**From:** Piozet, Jennifer  
**Sent:** Thursday, September 13, 2018 11:16 AM  
**To:** 'John Fioretta'  
**Subject:** RE: E. Santa Clara Plan--Arroyo Way traffic diverters

**From:** John Fioretta [mailto:fiorettajohn@att.net]  
**Sent:** Thursday, September 13, 2018 10:32 AM  
**To:** Piozet, Jennifer <Jennifer.Piozet@sanjoseca.gov>  
**Subject:** E. Santa Clara Plan--Arroyo Way traffic diverters

**From:** Piozet, Jennifer  
**Sent:** Monday, September 17, 2018 9:15 AM  
**To:** 'Annette Dow'  
**Cc:** Brilliot, Michael; Ceja, Patricia; Tran, David  
**Subject:** RE: Letter to planning commission -- could you please pass on to the commissioners?  
**Attachments:** GPT16-007\_Signed\_SupplementalMemo.pdf

**From:** Melinda Platt <Melinda.Platt@scchousingauthority.org>  
**Sent:** Thursday, October 4, 2018 3:53 PM  
**To:** Piozet, Jennifer  
**Cc:** Karl Lauff; Williams, Glen; Barry, David  
**Subject:** ESC: Urban Village Plan Comments  
**Attachments:** 18-1004 ESC Urban Village Comment Letter SCCHA&County.pdf

### PROPOSED REDEVELOPMENT AT 14<sup>th</sup> & EAST SANTA CLARA STREET

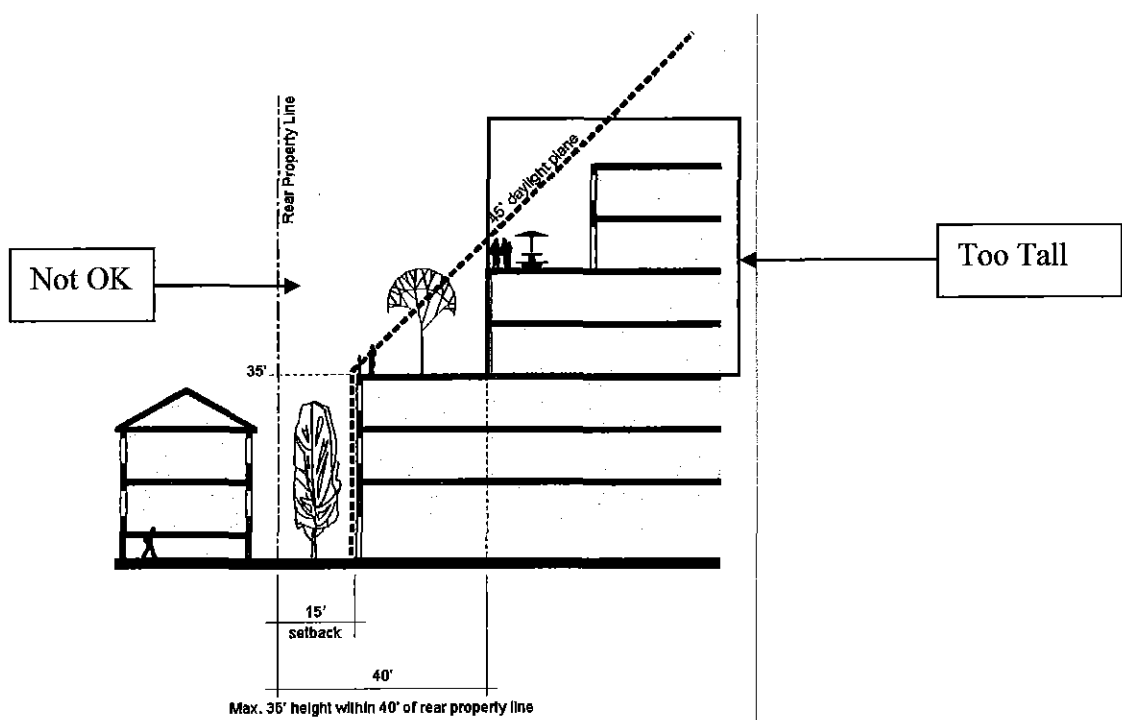
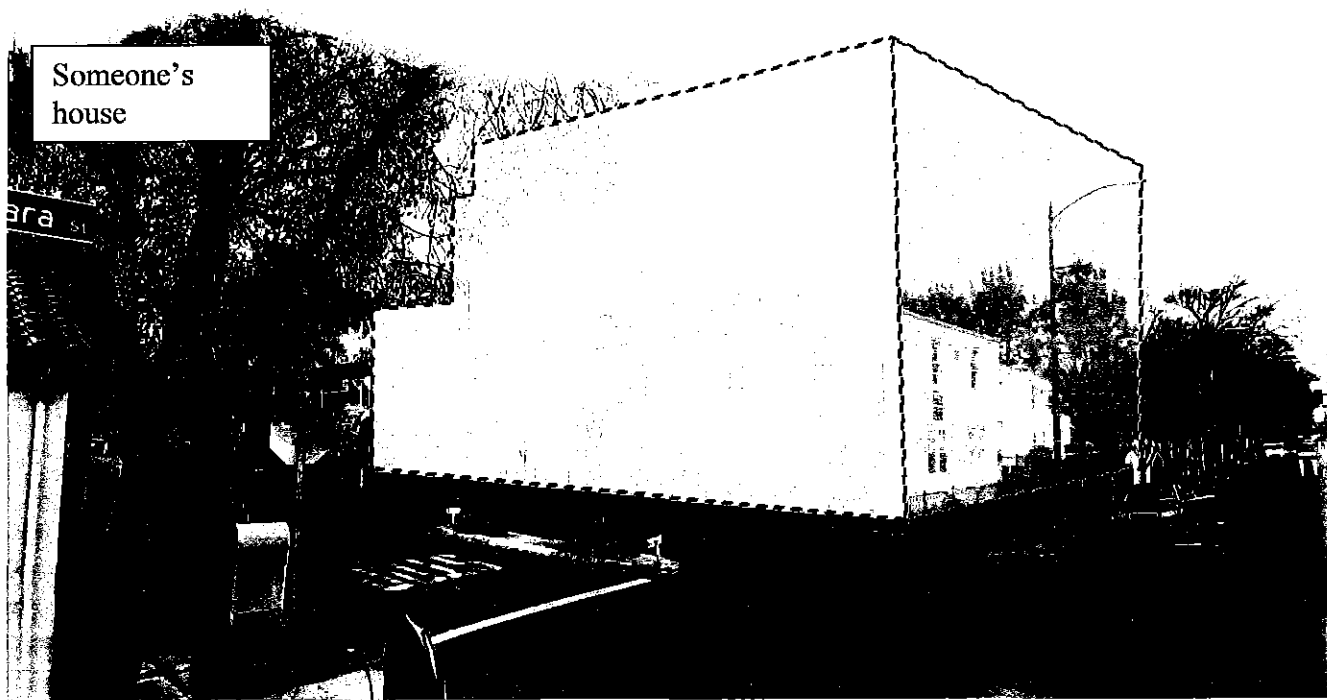
**CD-7.9** Build new residential development within Urban Village areas at a minimum of four stories in height with ~~the exception that a single row of 2-3 story development, such as townhouses, should be used~~ a step down in height when building new residential development immediately adjacent to single-family residential sites that have a Residential Neighborhood designation.

### THE EVEN WORSE REALITY

Adjacent to Residential Neighborhood Designated Property or Existing Single-Family or Duplex Building

Transitional Height Diagram Applies to properties inside and outside of the Urban Village boundary with a Residential Neighborhood General Plan designation

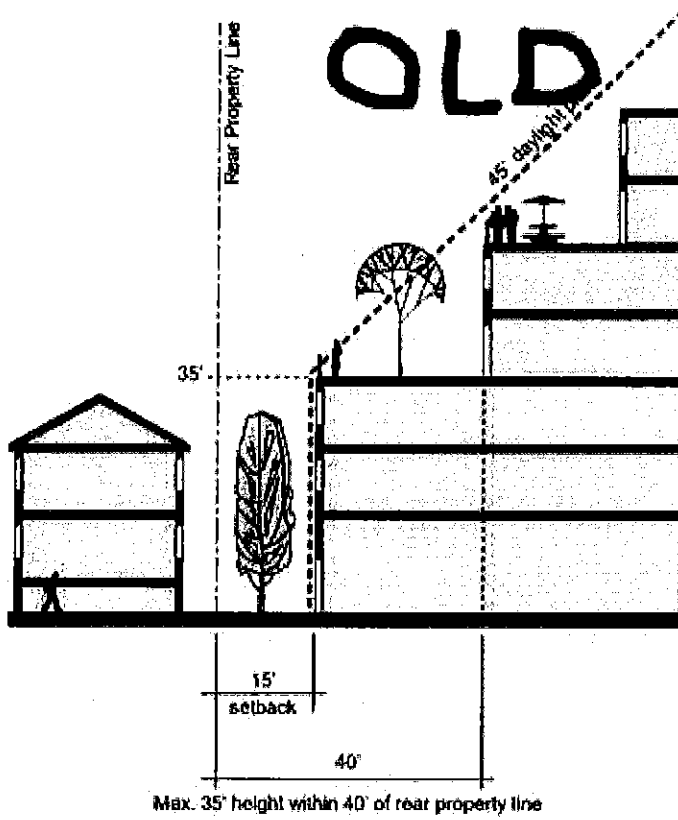
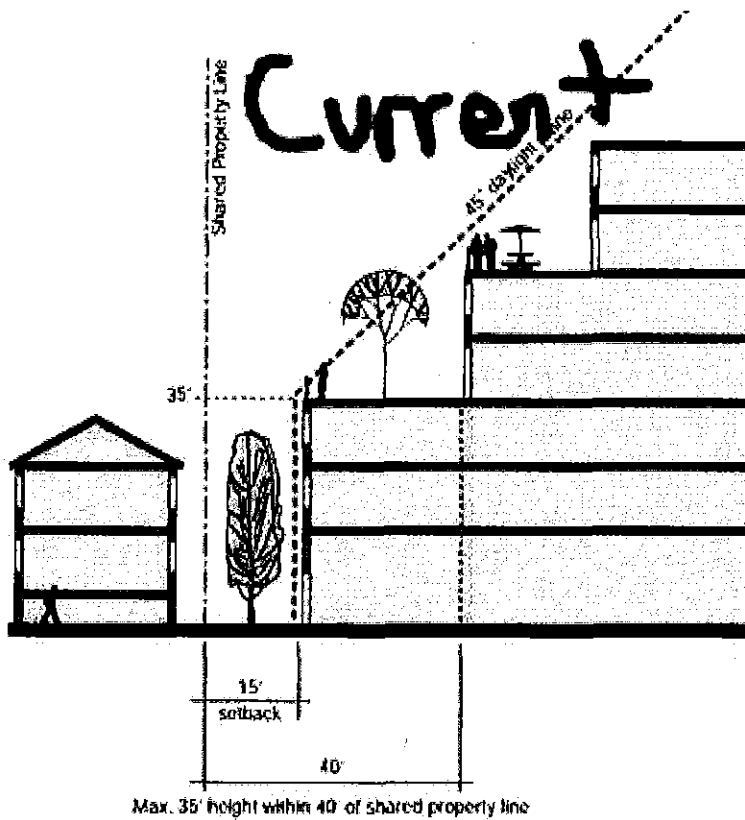
Also, Is there a way you could address my questions about the changes to allowable building heights? I would like to understand when, how and why decisions were made and then re-made regarding the building heights in the urban village area.

As background, it should be noted that the area next to Naglee Park has had an Urban Village land use designation since 2011 when the Envision San Jose 2040 General Plan was adopted and the height allowance of 120 feet since 2012 when the Zoning Ordinance was updated to match the Urban Village vision. The East Santa Clara Street Urban Village Plan never had a height limitation of 2-3 stories adjacent to single-family homes on the entire area of parcels near Naglee Park. There was concern expressed by the public in the beginning regarding heights next to Naglee Park, with a desire to have heights limited to 3 stories. There was confusion regarding General Plan Community Development Policy CD-7.9 and what it required of developments adjacent to Urban Villages. The original policy required that a "single row of 2.3 story development should be used when building new residential development immediately adjacent to single-family residential sites that have a Residential Neighborhood designation." This policy does not state that the entire area is limited to 2-3 stories in height, rather is explicitly states that the rest of the site must be occupied by a minimum of 4 stories of development.

Back in 2016, staff brought forward a change to General Plan Policy CD-7.9 at the direction of the City Council (General Plan Amendment File No. GPT16-007 [Planning Commission Staff Report](#), [PC to CC memo](#), and Supplemental memo attached) with the following changes. The City Council specifically requested that text be changed/incorporated into the policy that specifies that Urban Village design guidelines for building height and step downs adjacent to single-family properties should be deferred to Urban Village plans.

**CD-7.9** Build new residential development within Urban Village areas at a minimum of four stories in height with ~~the exception that a single row of 2-3 story development, such as townhouses, should be used~~ a step down in height when building new residential development immediately adjacent to single-family residential sites that have a Residential Neighborhood designation. Individual Urban Village Plans may establish more specific policies or guidelines to ensure compatibility with adjacent single family neighborhoods, and development should be consistent with these policies and guidelines, established in approved Urban Village Plans.

The East Santa Clara Street Urban Village Plan achieves even the former version by limited the height of development *within 40 feet of the property line shared with Residential Neighborhood designated properties* by limited the height to 35 feet (which allows 2-3 stories of height). Also consistent with this Policy, since the second Urban Village workshop (where heights were discussed), the heights next to Naglee Park were shown

at 65 feet maximum (back in 2015) and the draft Plan has always included a daylight plane with setback requirements (see both 2016-OLD and 2018-NEW diagrams below).

**EAST SANTA CLARA MASTER PLAN SITE**

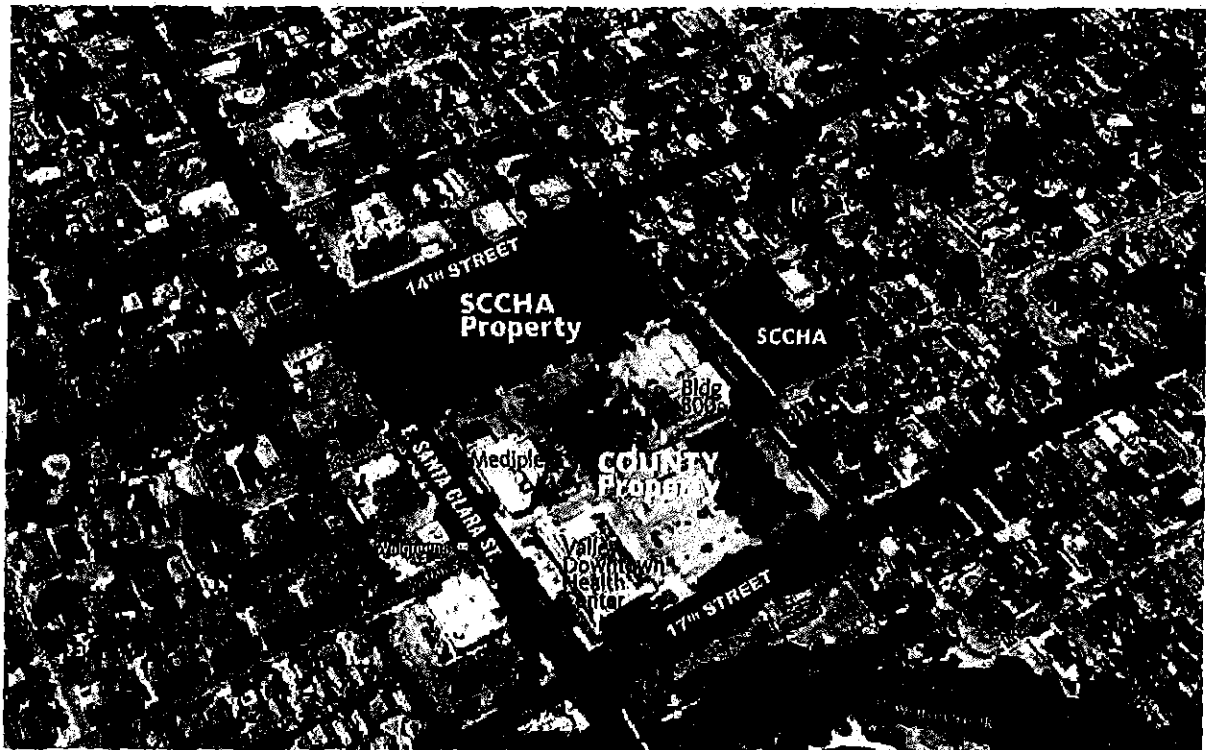
In addition to prioritizing housing, SCCHA and the County are both currently at full space capacity in their existing commercial office spaces and are looking to the Master Planning Site to accommodate for an expanding workforce, contributing to the City's desired job growth within the area. Both entities envision this site to become a "Housing Hub" where individuals from not only the East Santa Clara Street communities but also communities across Santa Clara County can come together to address the housing needs of themselves and of others. There is currently one location within the ESC UVP which states "ground floor retail required along East Santa Clara Street" (Page 3-4, Figure 3.1). With a visitation record between 56,000 and 58,000 clients per year for SCCHA alone, we believe this will provide ample activation of the ground floor. We encourage the City to revise this language to remain flexible in the ESC UVP guidelines for the methods of ground floor activation within commercial spaces, as well as to remain consistent with the rest of the document.

SCCHA and the County also recognize the City's desire to provide outdoor public spaces at which the community can gather and come together. Currently, the ESC UVP manifests this desire as a large public plaza within the Master Planning Site. However, Roosevelt Park and Community Center are immediately adjacent to the Master Planning Site and provide the desired large public space for gathering. SCCHA and the County expect that we can provide needed outdoor spaces for use not only by the on-site residents and workforce, but also the surrounding communities. We believe the desire for outdoor spaces can be met on SCCHA- and County-owned property through a variety of tools and shapes that will provide respite and gathering opportunities that meet the needs of the surrounding neighborhoods as well as the needs of the onsite users rather than via a large plaza.

We are also very supportive of the revision that 15<sup>th</sup> street be transformed into a north-south public paseo. However, the ESC UVP also states the necessity for two east-west public paseos. We have concerns about the ability to keep the second northern paseo a safe space for people to gather because it is narrower in width and nestled between buildings. In addition to this, we question the necessity of this second northern paseo given its close proximity to East St. John Street which is lined with larger pedestrian thoroughfares and in progress to become a bike boulevard. We encourage the City to remain flexible within the ESC UVP in its methods of addressing open space and connectivity for bikes and pedestrians.
